AGENDA ITEM 9
PLANNING & DEVELOPMENT SERVICE
PLANNING DIVISION
455 Mountain Village Blvd.
Mountain Village, CO 81435
(970) 728-1392

TO: Mountain Village Design Review Board
FROM: John Miller, Senior Planner
FOR: Design Review Board Public Hearing; March 4, 2021
DATE: February 22, 2021
RE: Staff Memo – Initial Architecture and Site Review (IASR) Lot 161D-1 Unit 19

Case Summary: Steve Morton of Morton Architects (Applicant), on the behalf of Tommy and Sloan Lusk (Owner) is requesting Design Review Board (DRB) approval of an Initial Architectural and Site Review (IASR) Application for a new single-family detached condominium located at Lot 161D-1, Unit 19, 1 La Sal Lane. The Lot is 7,500 square feet and is zoned Multi-Family. The proposal includes a detached condo with an approximate gross square footage of 7,281 square feet. Because of the home's location near the top of Coonskin Ridge, additional development regulations must be addressed in addition to the general Design Review Standards – specifically, CDC Section 17.5.16: Ridgeline Lots. The applicant has provided all the required materials for the IASR for the proposed home. It should be noted that in 2008, Unit 19 was approved

1 SITE UTILITY PLAN

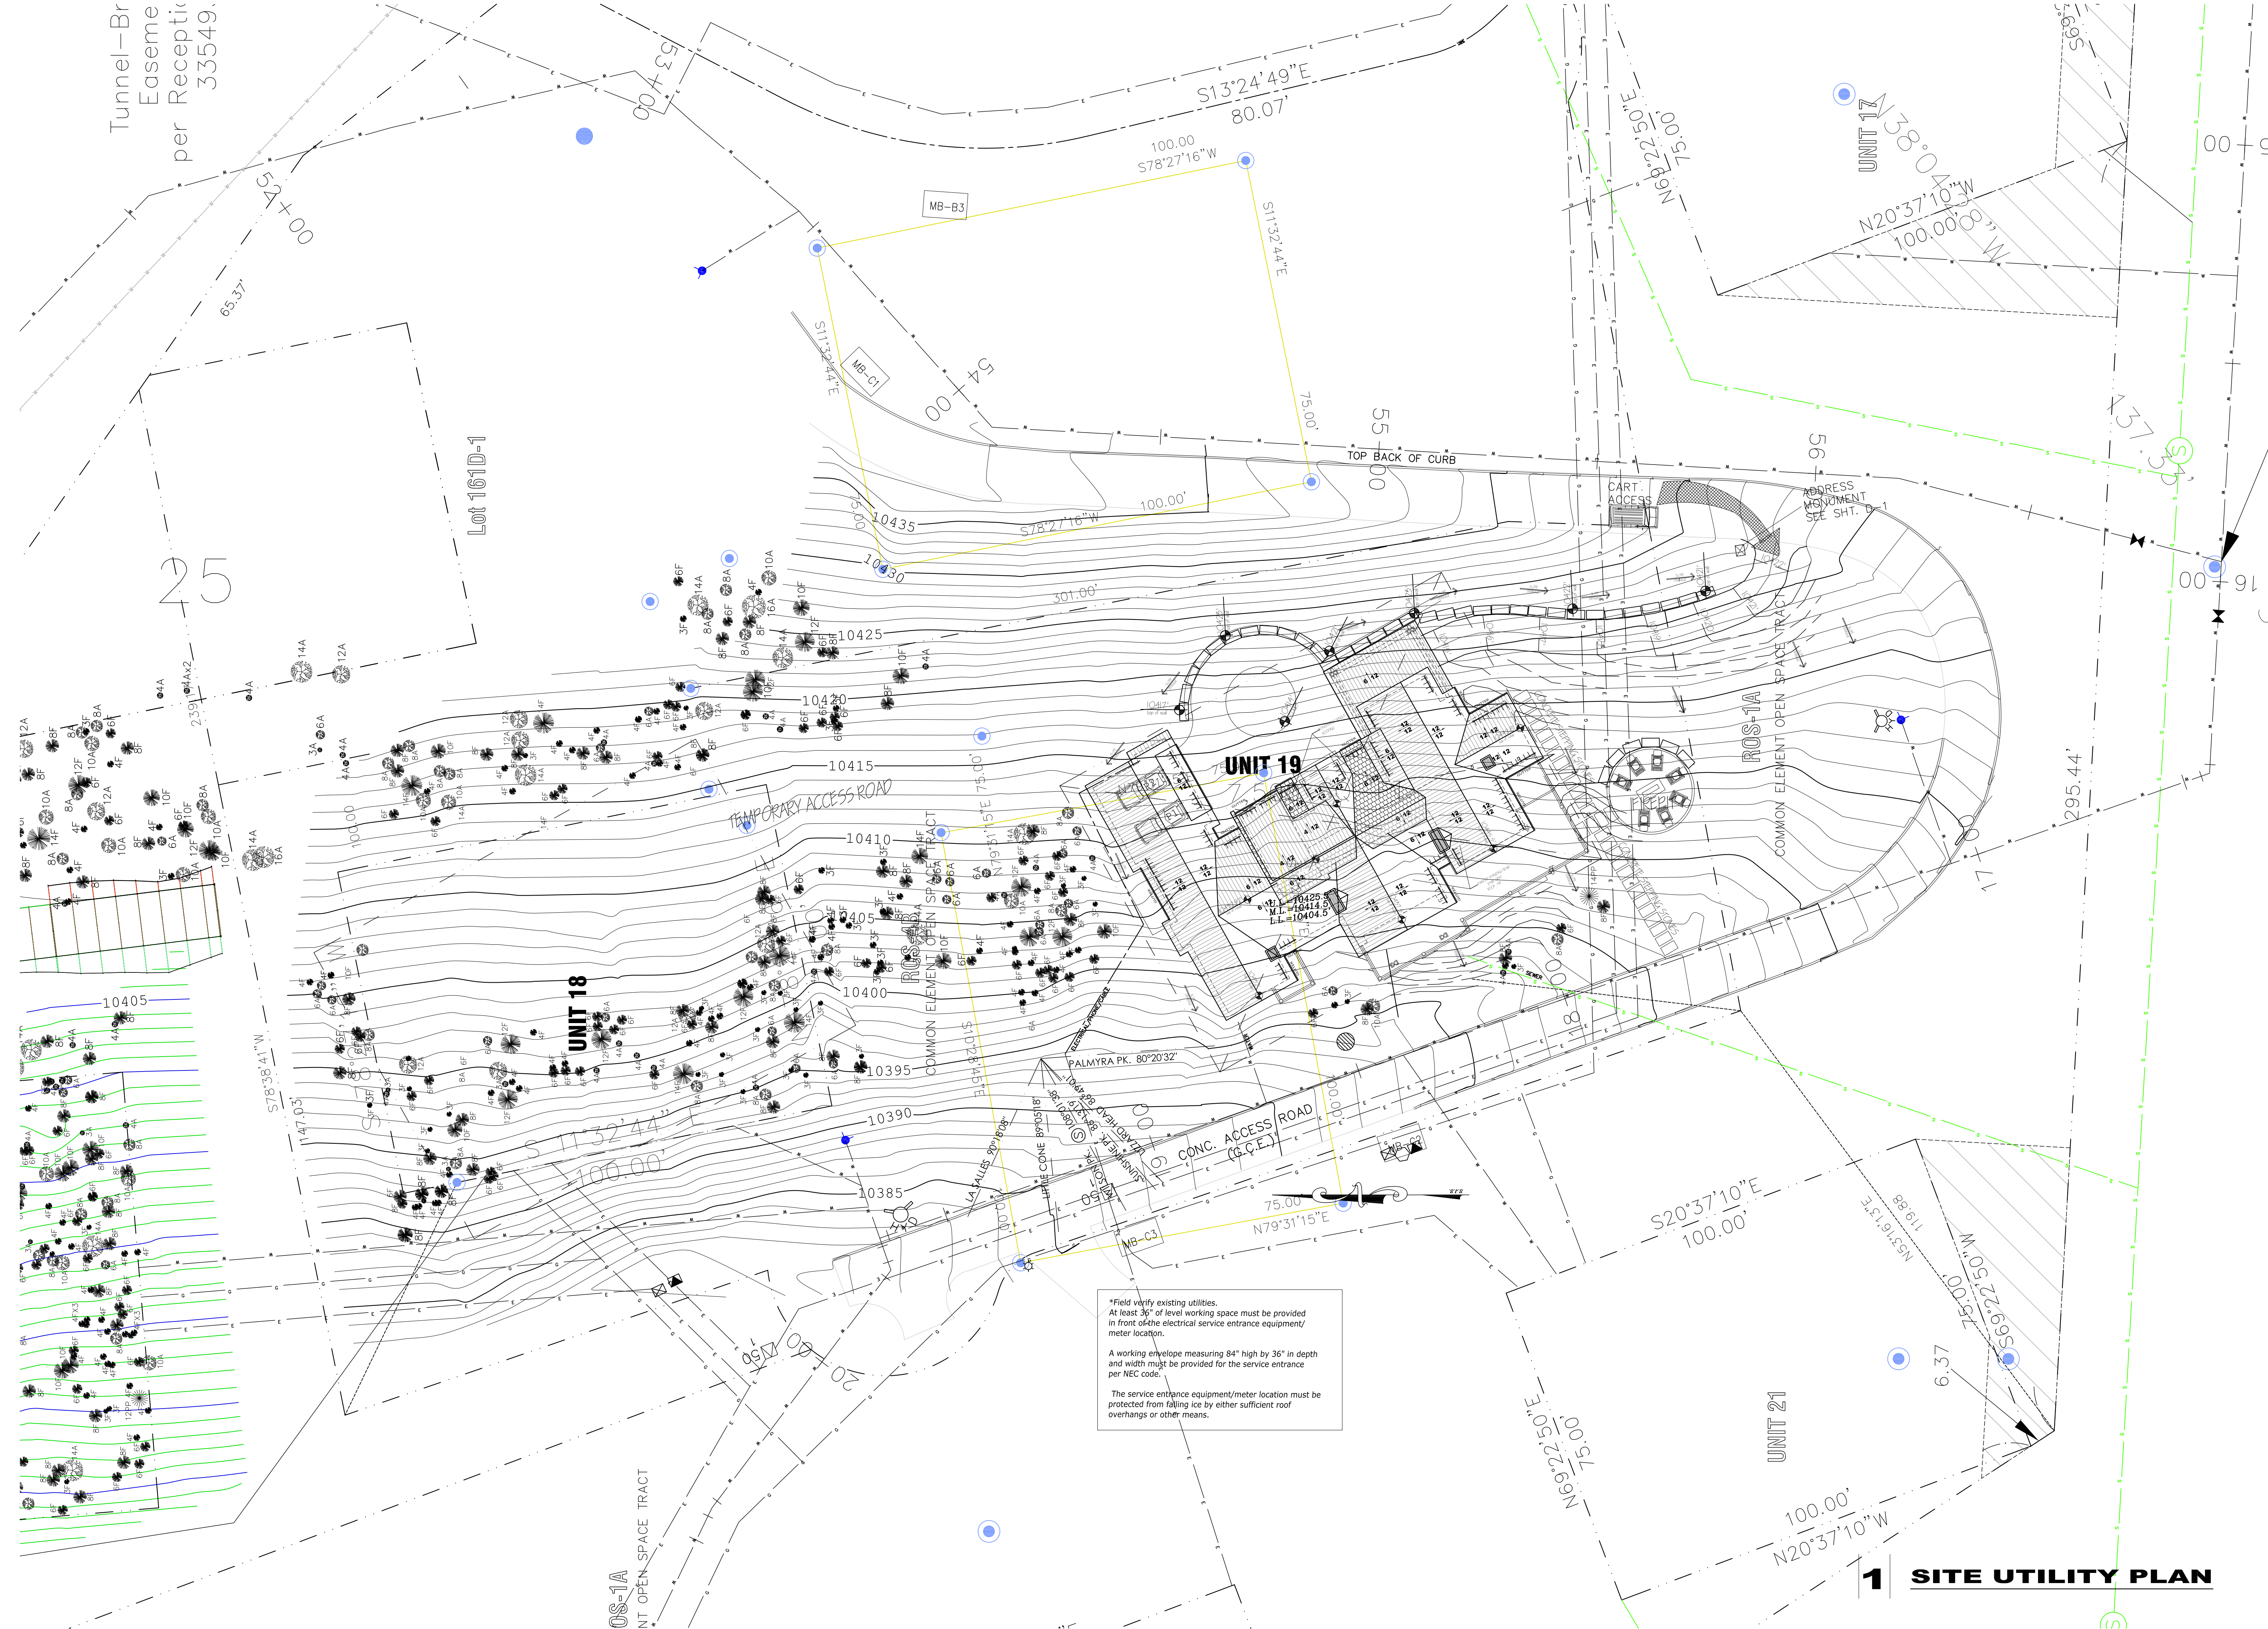
Staff: All utilities are currently located within proximity to the home. The applicant shall work with the Public Works Director before the final review to verify the specific locations of the connections for the home. The plan set shows the proposed connections and the locations of the proposed utilities based on field research.

- 5) Prior to the issuance of a building permit, the applicant shall field verify all utilities and submit a revised utility plan to the public works director identifying the location of utilities and connection points.

NORTH ELEVATION
1/4" = 1'-0"

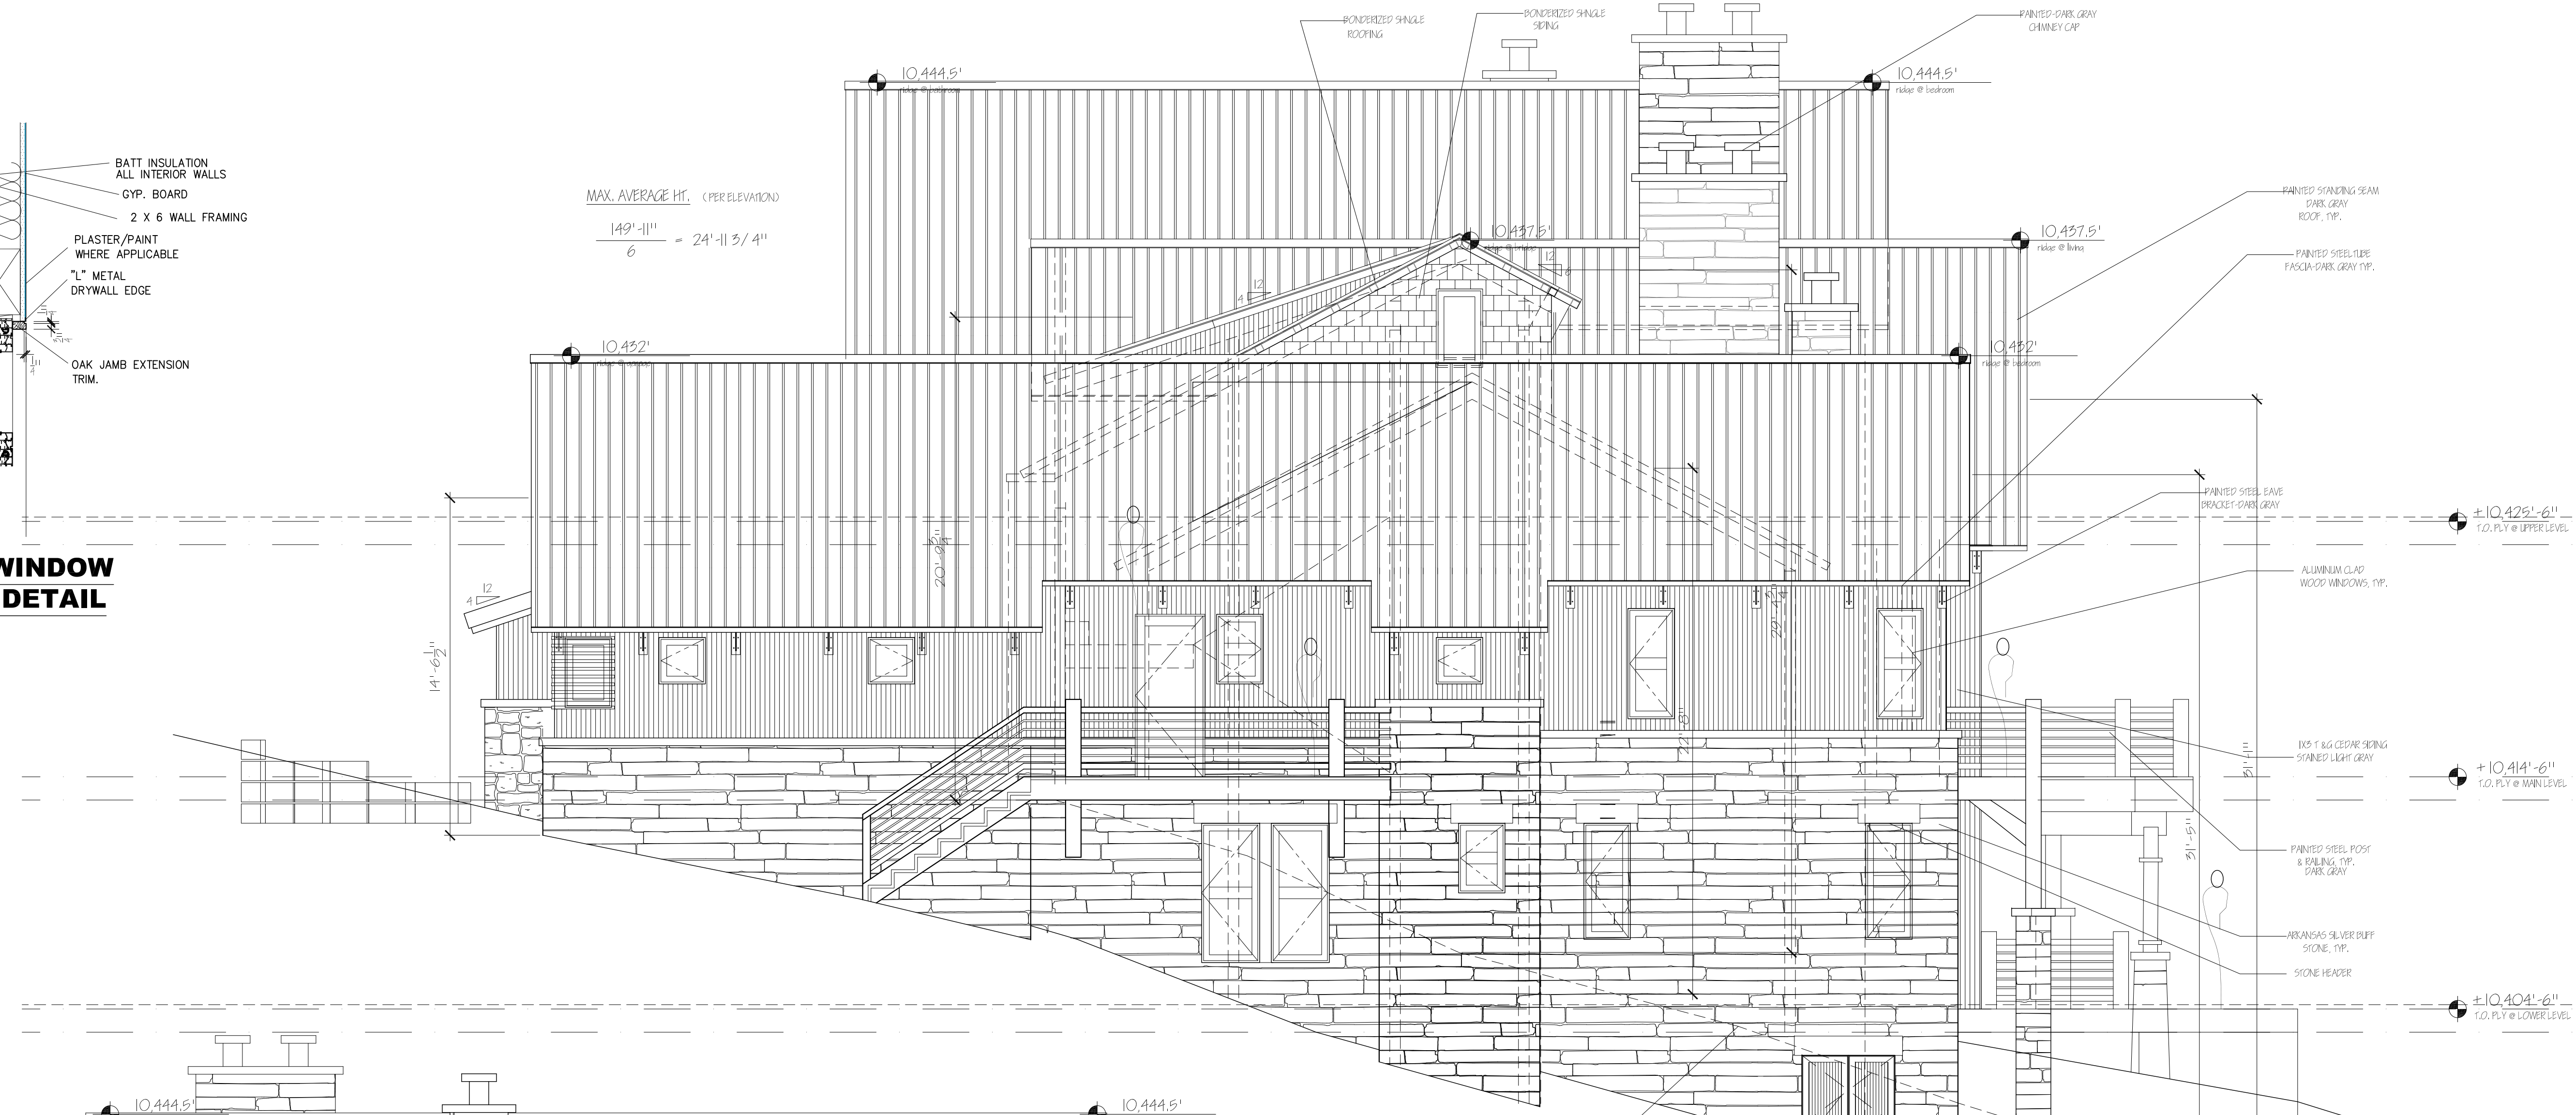
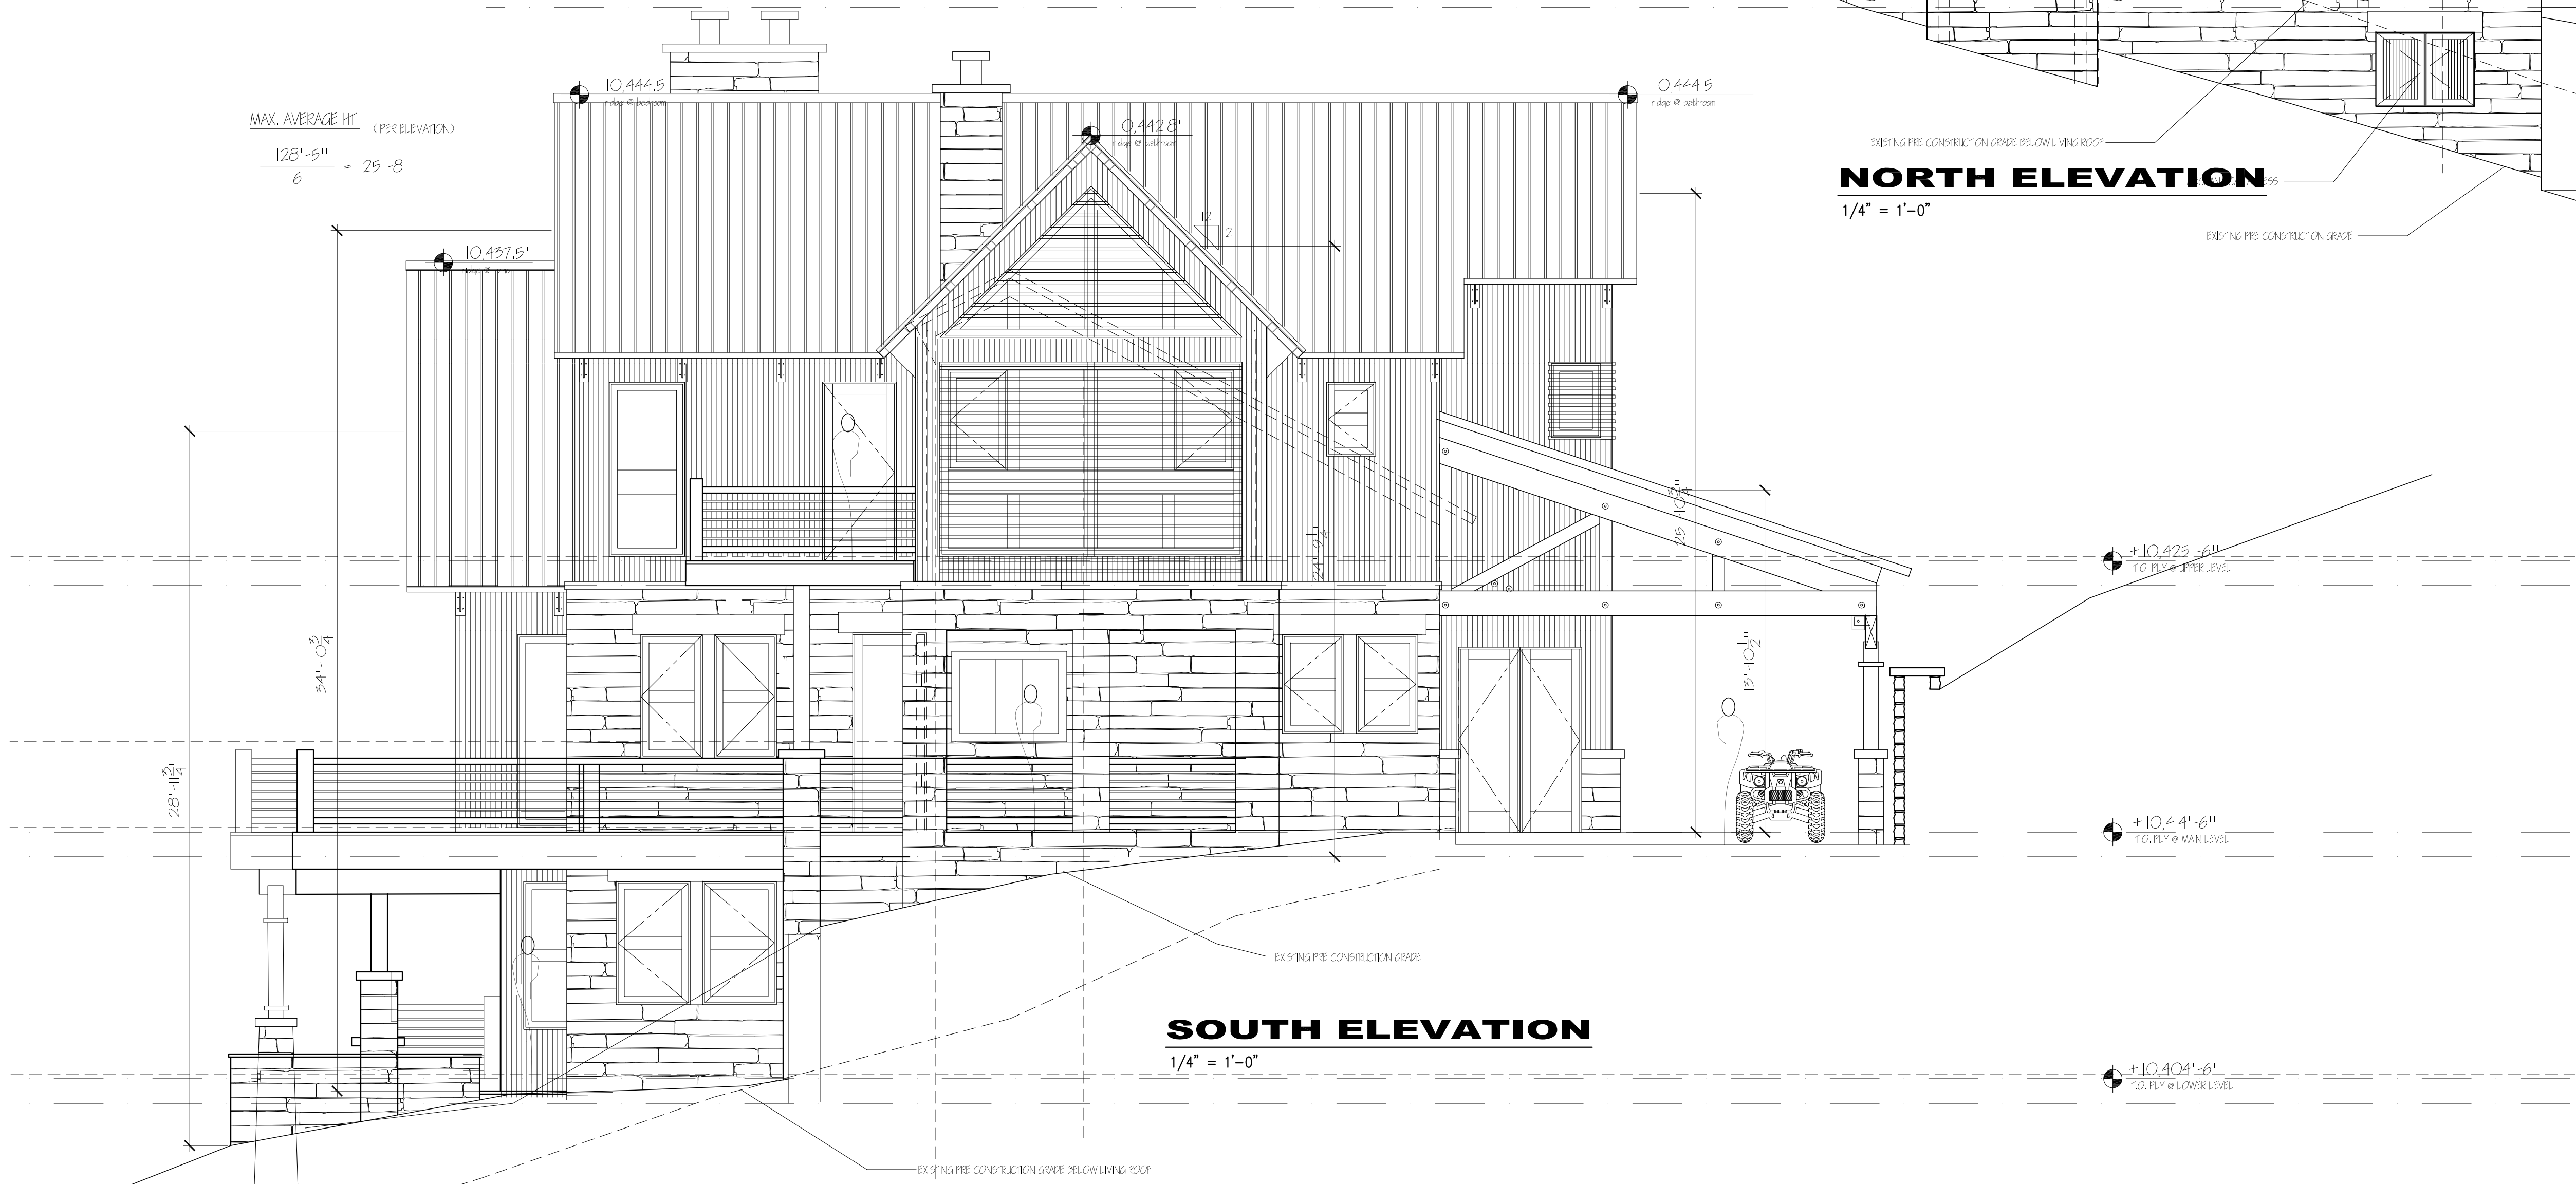
Staff: The Maximum Building Height and Average Building Height analysis has been provided on pages A3 and A3.1 of the submitted plan set and shown above in Table 1. With a Maximum Height of 40'-6" and a Max Average Height of approximately 25'-0", any future approval should condition that a height survey is required prior to the issuance of a framing inspection to determine the heights comply with any DRB approved plan and the development agreement for Coonskin Ridge.
